# Pentium® Processor Specification Update

Release Date: March 1997

Order Number 242480-025

The Pentium® processor may contain design defects or errors known as errata. Characterized errata that may cause the Pentium processor's behavior to deviate from published specifications are documented in this specification update.

### 2. ***Incorrect TCP Pinout Drawing***

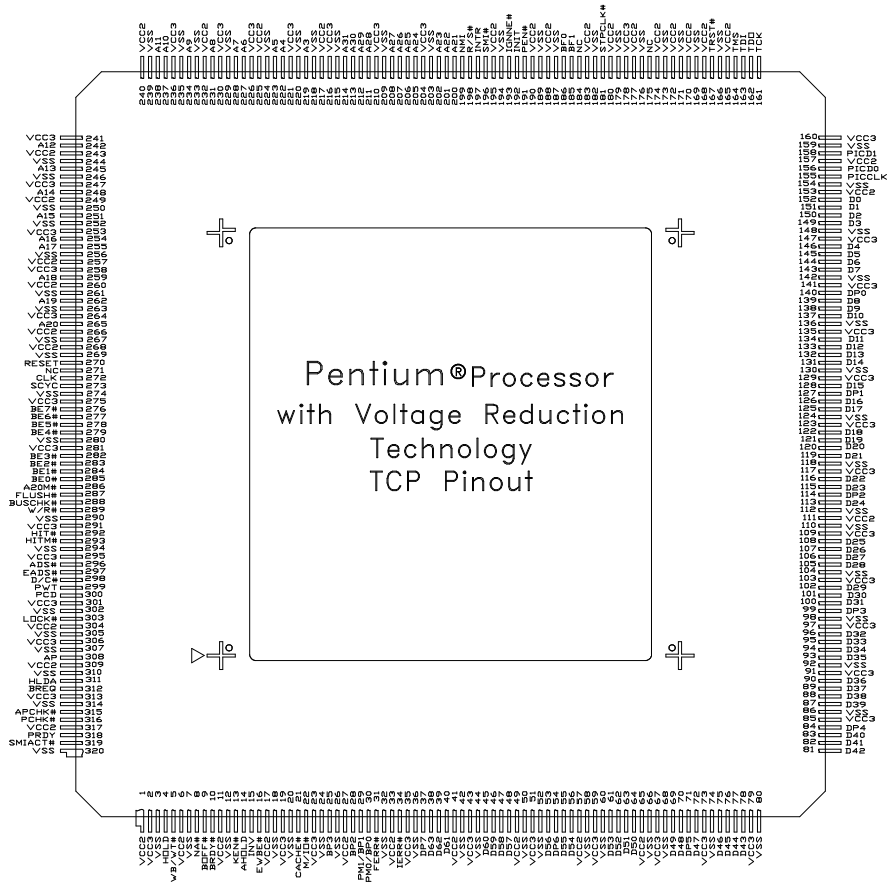
The TCP pinout drawing on page 8 of the Pentium Processor with Voltage Reduction Technology Data Sheet was inadvertently rotated. The correct orientation is shown below.
